Project No.: R.026175.001

This Addendum forms part of the Contract Documents and amends the original Drawings and Specifications dated 2015-09-04, previous Addenda if applicable and as noted below. This Addendum consists of 7 pages and Drawings as listed below.

END OF ADDENDUM NO. 2

PROJECT TITLE
 NORTH DISTRICT BUILDING
 RECAPITALIZATION

AR1.1

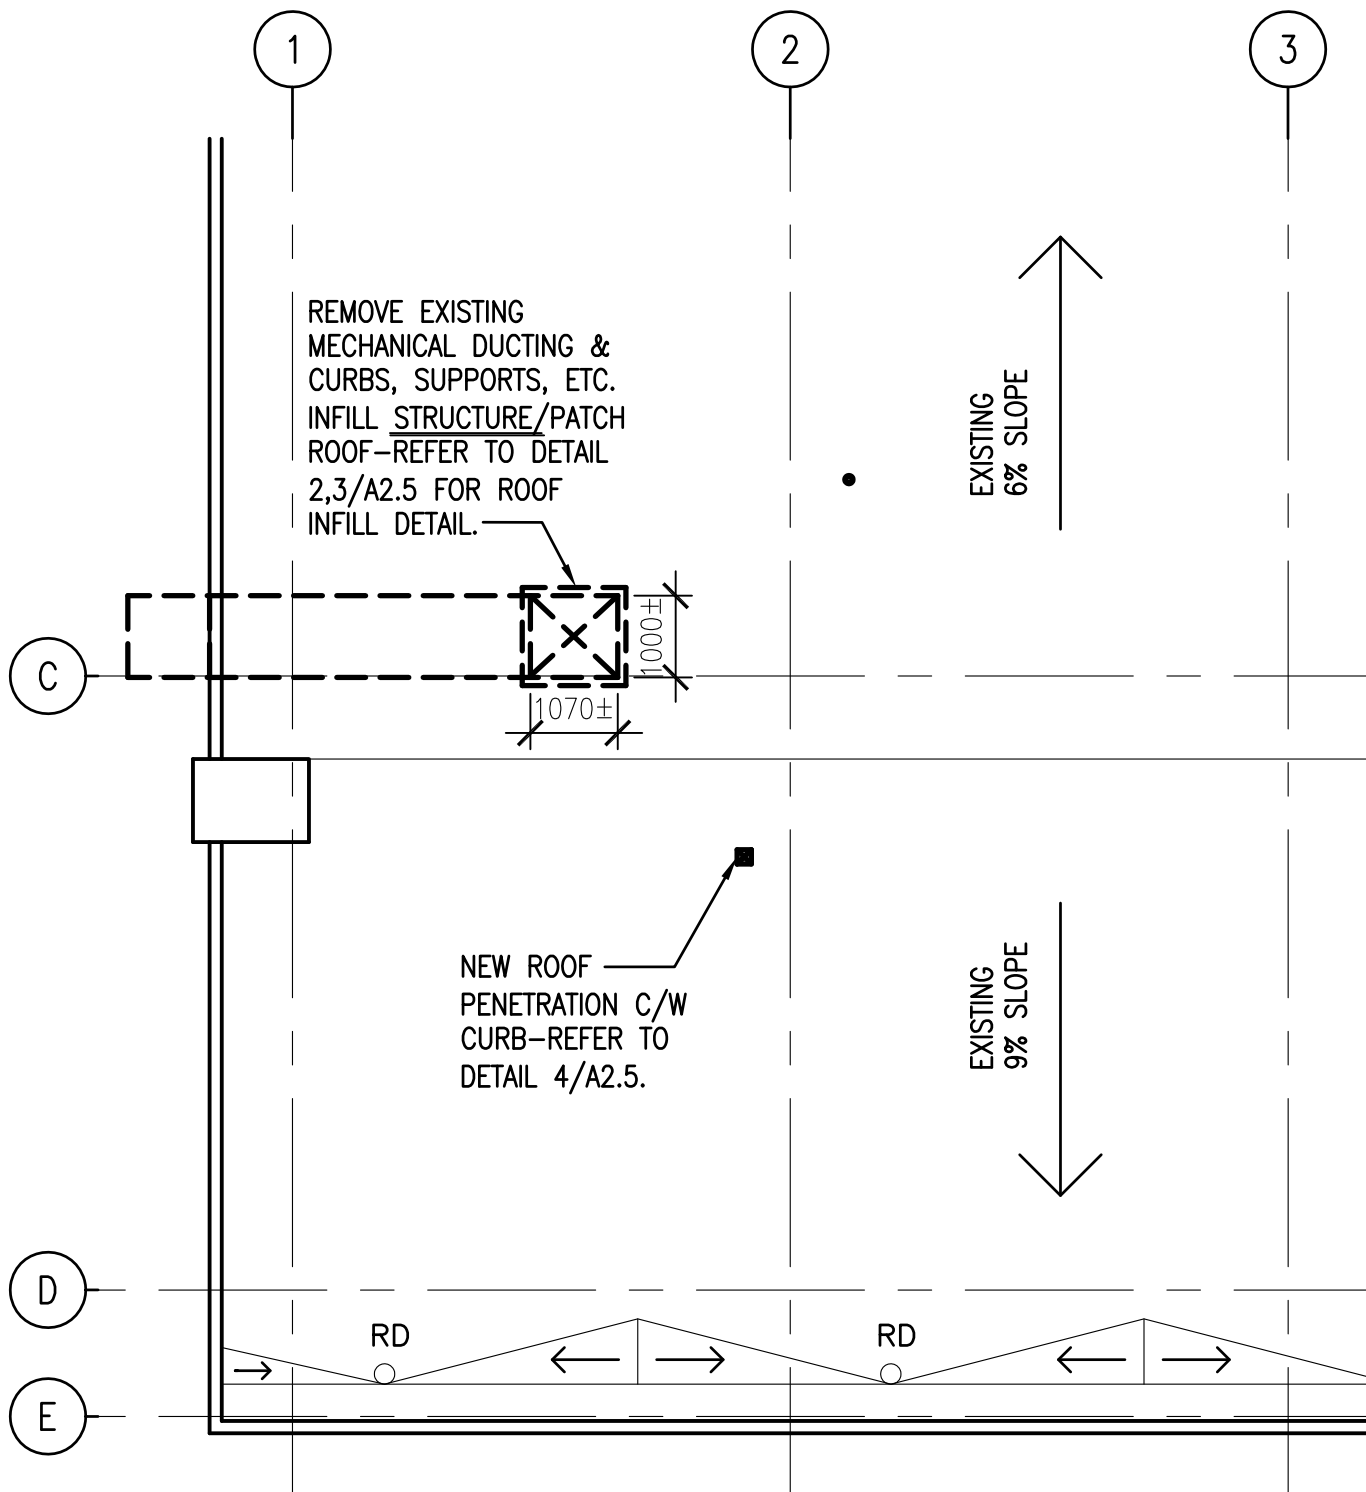
A-2-12 REF. DRAWING A2.5 ROOF PLAN

1. Revise detail 1/A2.5 as shown on Drawings AR1.1 & AR1.2, attached to this addendum.
2. Detail 1/A2.5: Approximate duct opening dimensions shown (to be site confirmed) on drawings AR1.1 & AR1.2, attached to this addendum
